# City of Alamogordo

Re: **Addendum 1**  
**Public Works Bid No. 2021-005**  
**Alamogordo Park Restrooms**

Addendum Number 1 is issued to provide changes and/or clarifications to the questions asked on the above referenced bid. Date, time, and location of submitting this bid remains unchanged.

**AD1.0**

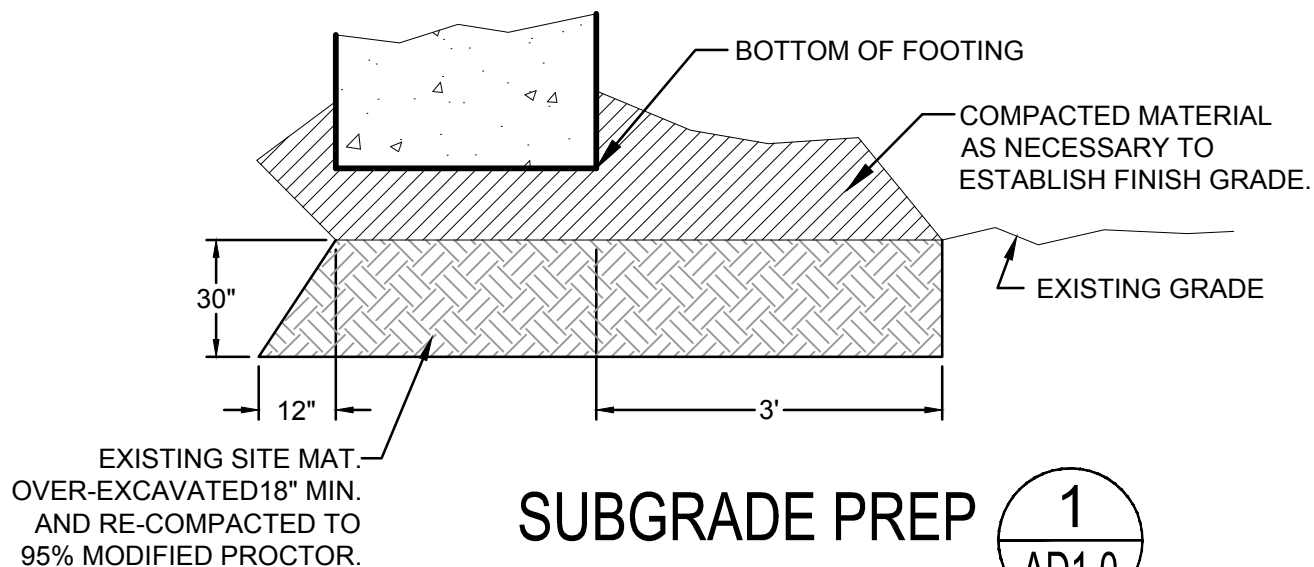
**Question 9** – Bid Lot No. 2 Alternate to Bid Lot 1 Unclassified Excavation has the same description as the other items, And the plans call for the pad to be 20.5” above adjacent grade so what is this lump sum item to cover?

**Response 9** – The finish floor elevation for the building (bid lot #1 or bid lot #2) shall be 4275.2 which is 20.5” above adjacent grade, this is required to keep building out of the flood zone. The contractor will be required to bring in additional fill as needed for the project, in order to elevate the building to the required finish floor elevation. See attached AD1.0 for required sub-grade preparation.

**FOUNDATION PLAN (BALLOON PARK) 1**  
 BID LOT #1 1/4" = 1'-0" S100

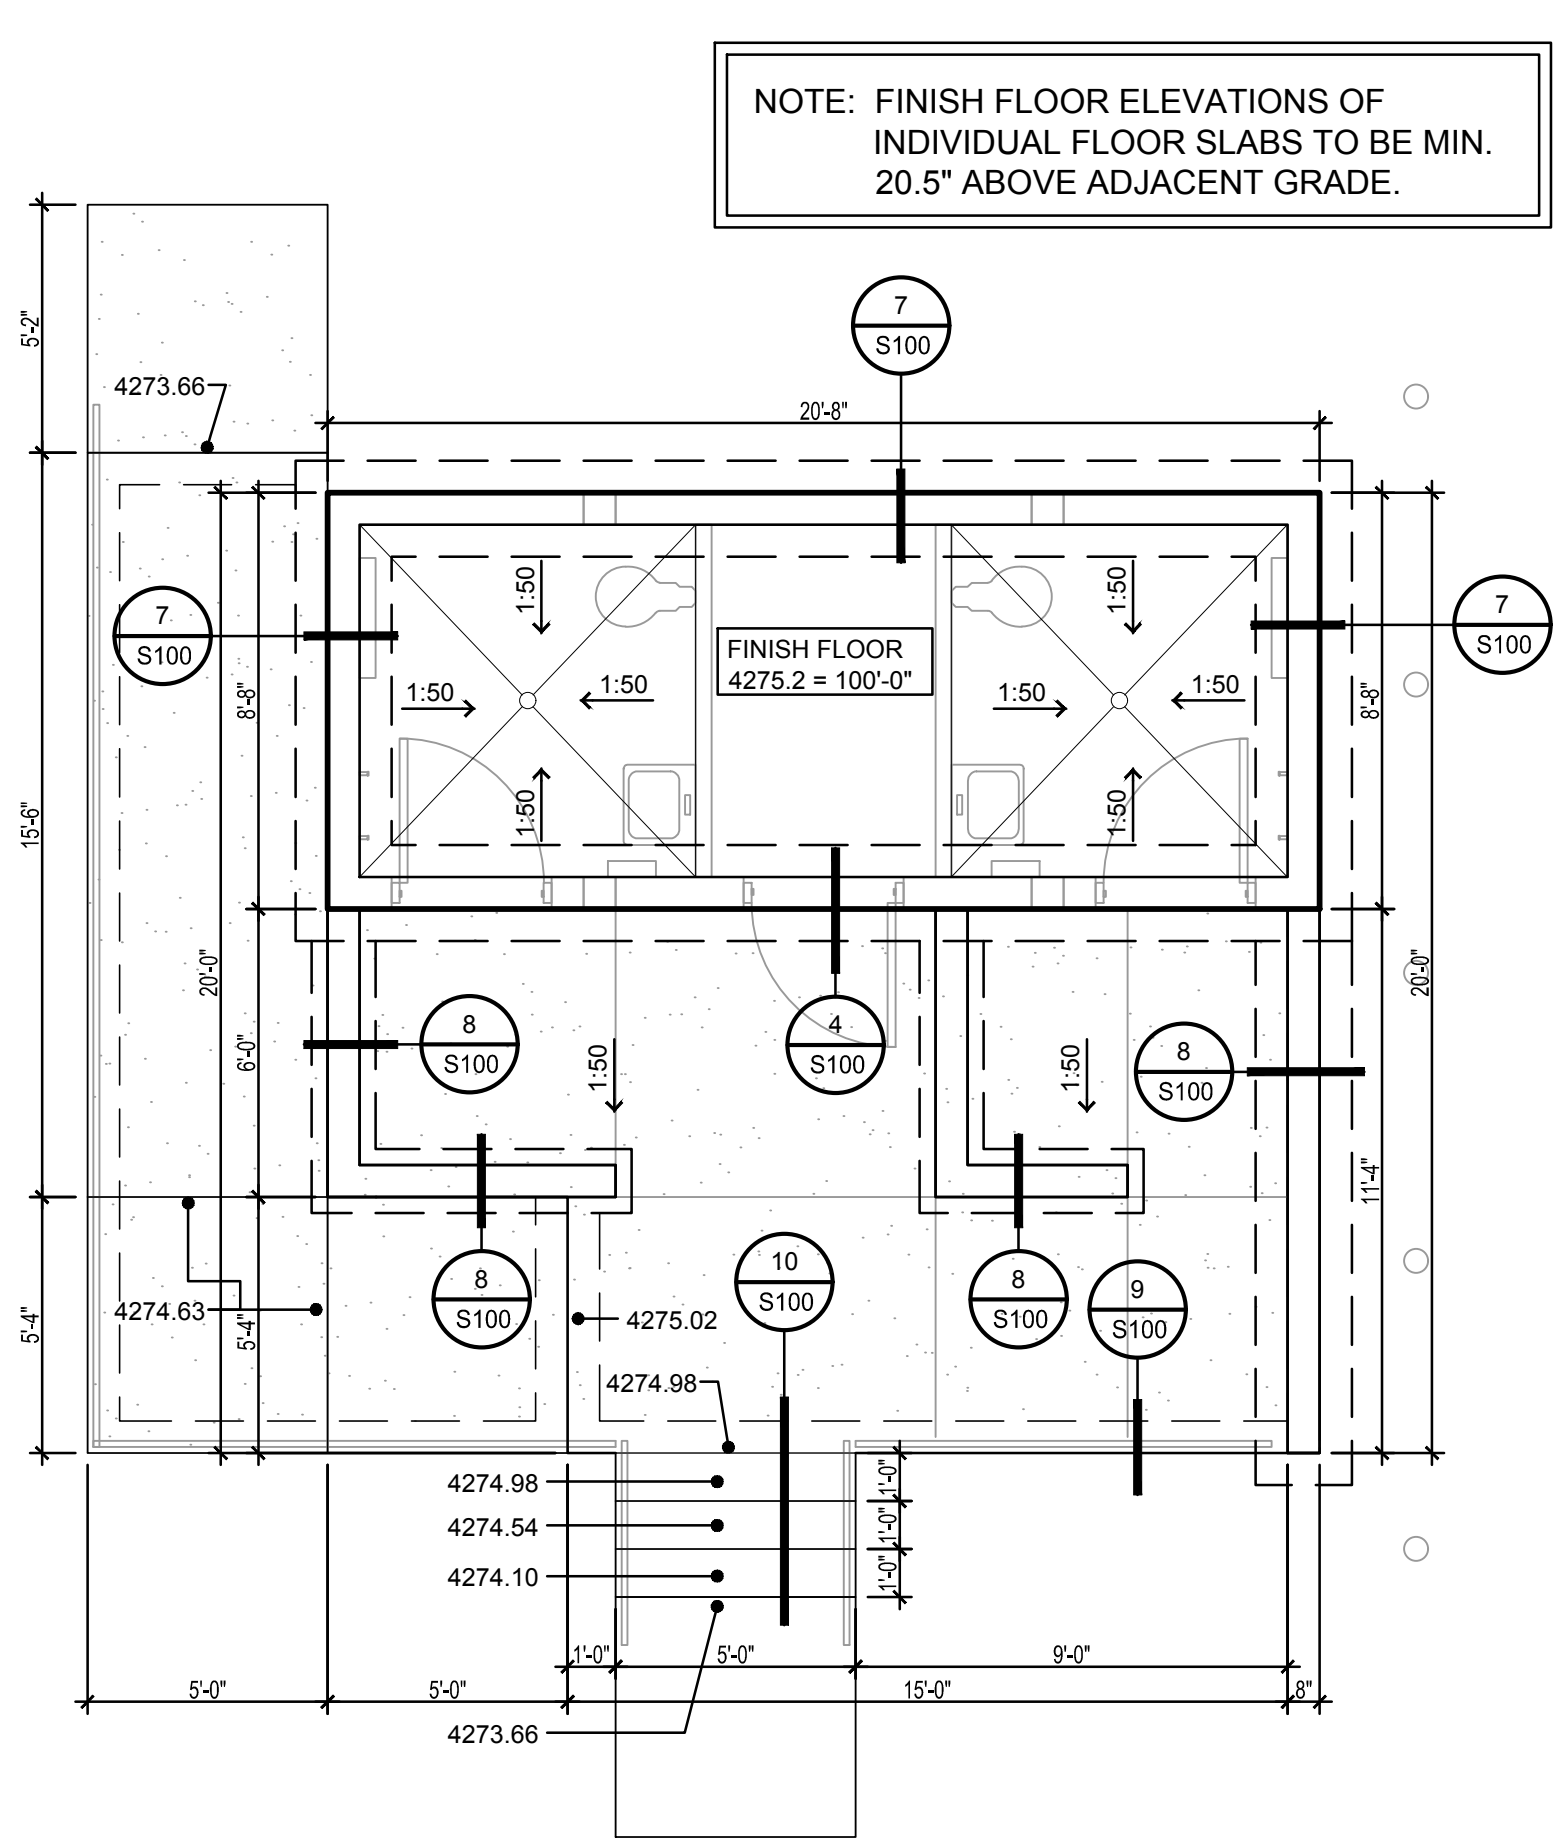
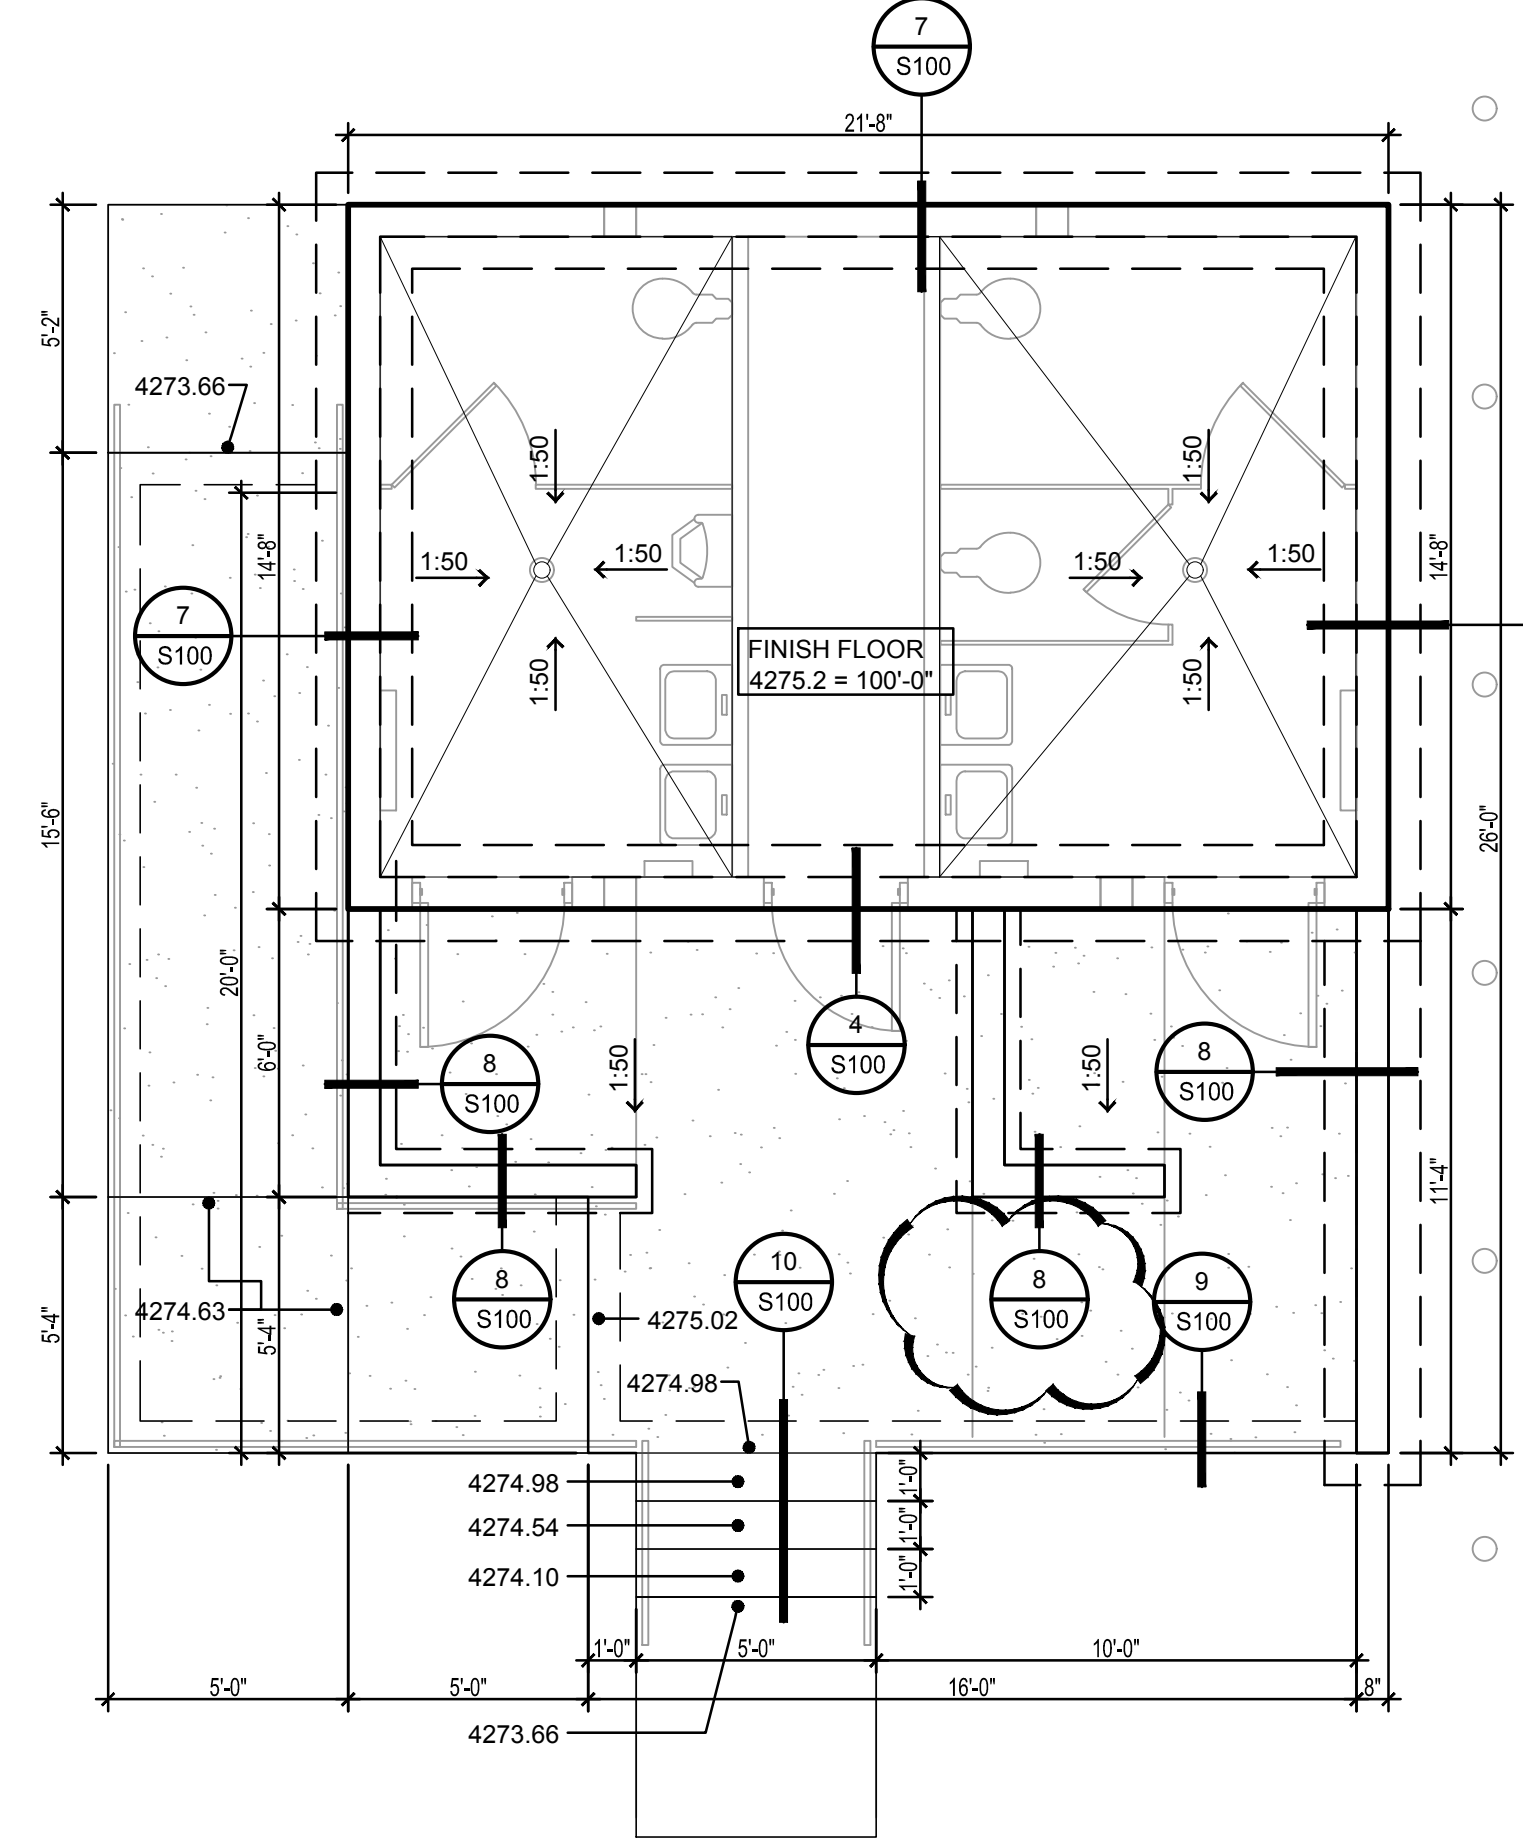
**Question 6** – On sheet S-100, details 1/S-100 and 2/S-100 show different footings (8 vs. 7, respectively) under the right side, short CMU wall. Please clarify

**Response 6** – The detail noted under the right L-shaped wind break wall (2/S100) should reference detail 8/S100. See revised sheet S100.

**WELD PLT. DTL. 11**  
 3" = 1'-0" S100

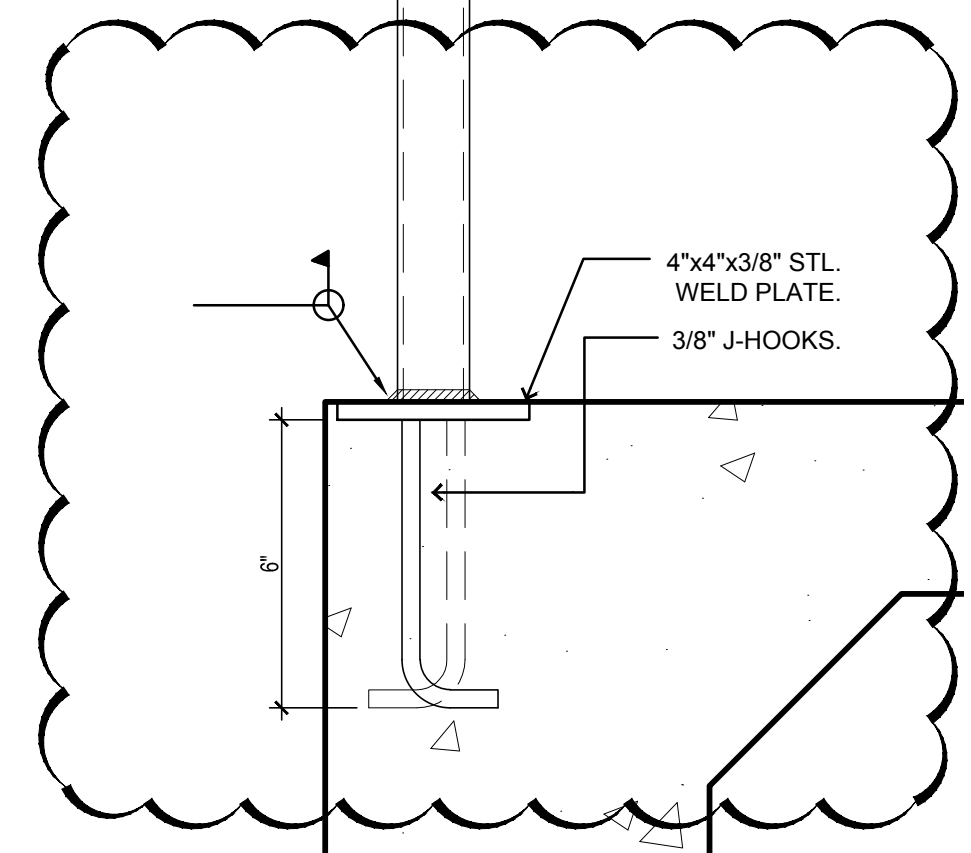
**Question 7** – How are the guardrails to be fastened, sleeves, weld plates, anchors, or other method?

**Response 7** – Guardrails are to be fastened with 4x4x3/8” weld plates with (2) J-Style 6” anchors each embedded in concrete, contractor to provide a min 8” thickened slab at weld plate anchor locations. See revised sheet S100 Weld plate detail.
